SCHEDULE A: Applications with Recommendation

ltem No: 09		Date of Committee: 29/08/2014	
Appn Ref No: 14/0396		Applicant: Mr & Mrs Julian Coulthard	Parish: Wetheral
		Agent: AJ & D Chapelhow Limited	Ward: Wetheral
Location: Red Beeches, 24 Scotby Village, Scotby, Carlisle, CA4 8BS			
Proposal: Replacement Of Timber Sliding Sash Windows To Rear Elevation With Double Glazing Units (LBC)			
Date of Receipt: 20/05/2014		Statutory Expiry Date 15/07/2014	26 Week Determination

REPORT

Traditional Sliding Sash Mid/Cill Section.

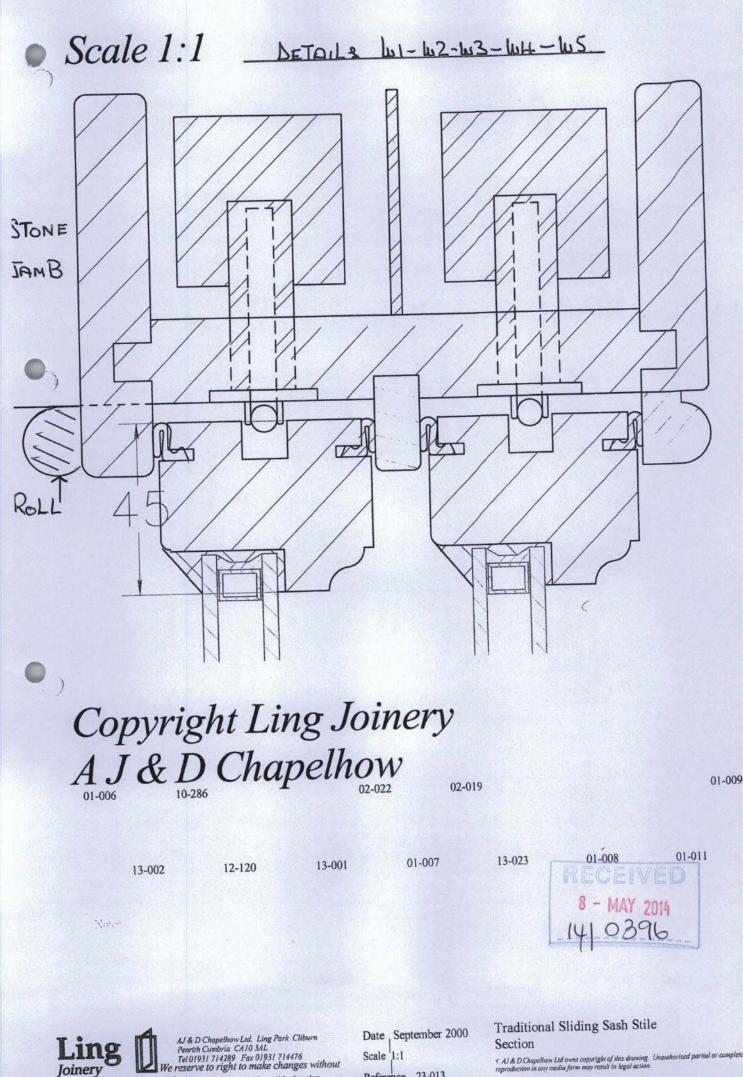
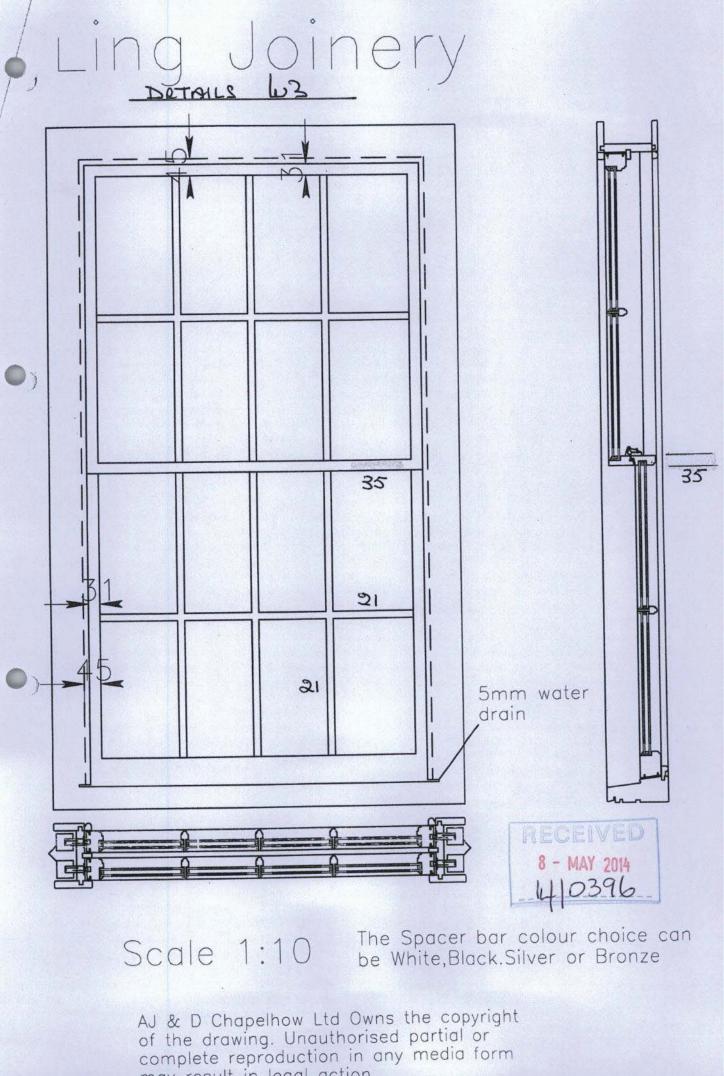
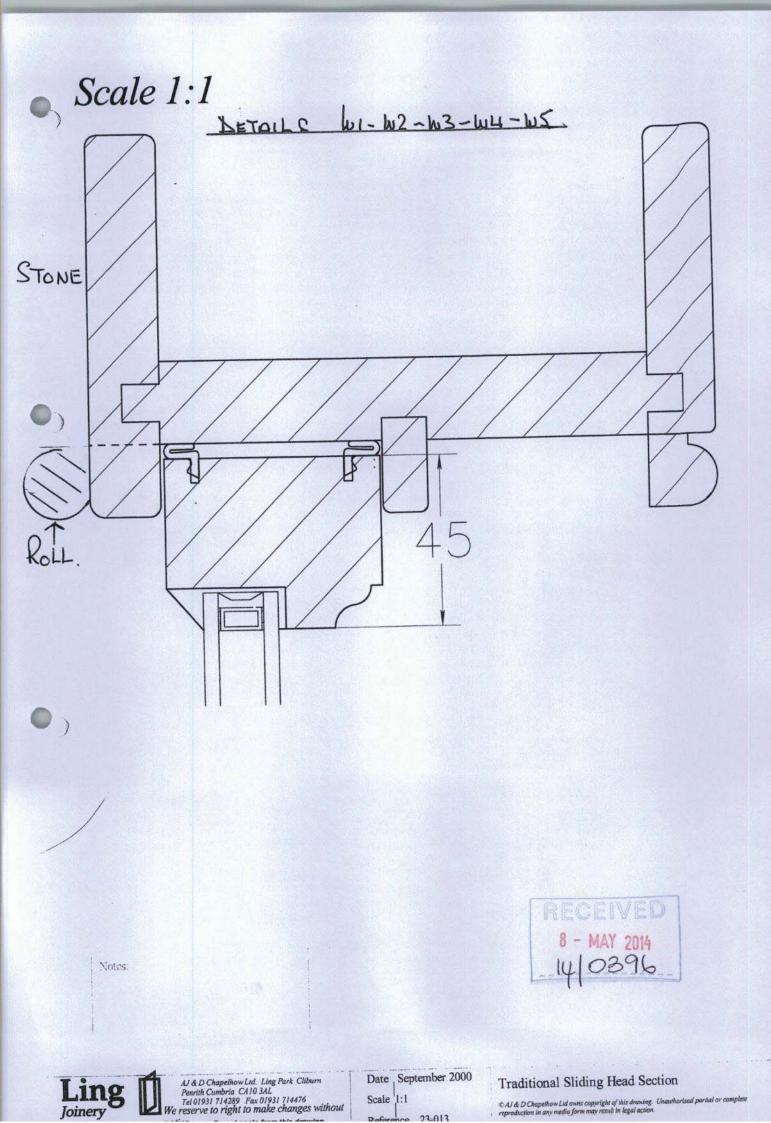
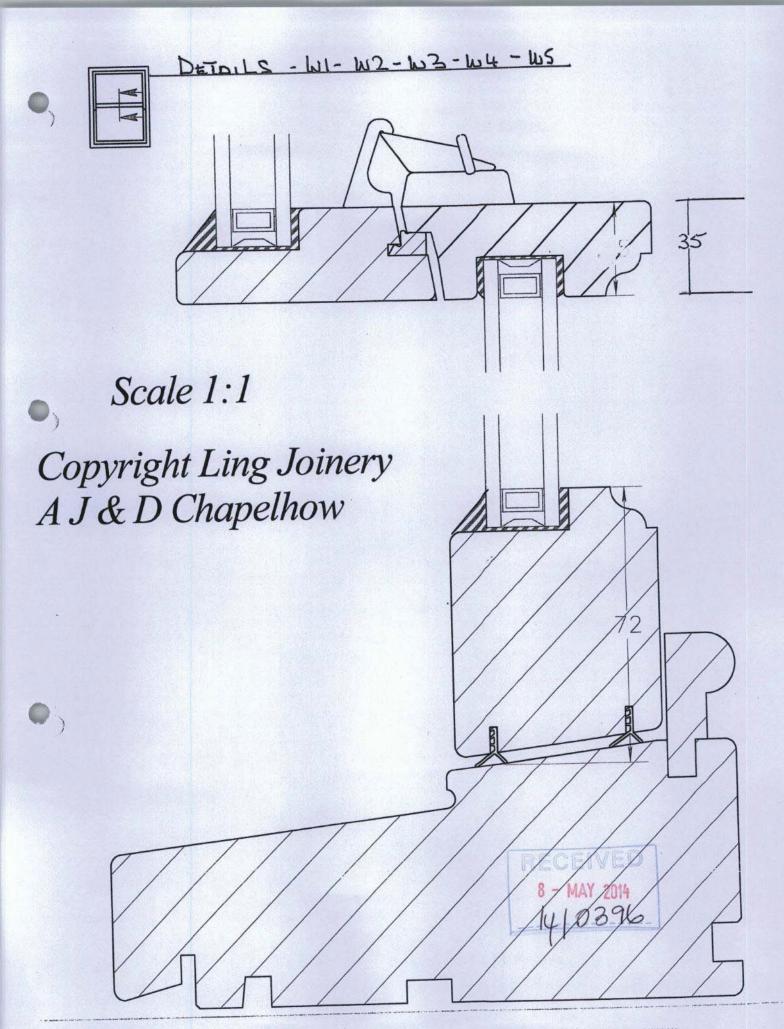
- 6.5 No detail of the existing windows (e.g. cross sections of glazing bars) have been provided by the applicant to illustrate the supposed match between the existing windows and the proposed units. However, the proposed double glazed units appear to be at least 20mm thick in contrast to existing glazing at around 3mm thick. This implies that the supporting joinery cannot be a close match to the existing woodwork if it is to support such an increase in depth and weight.
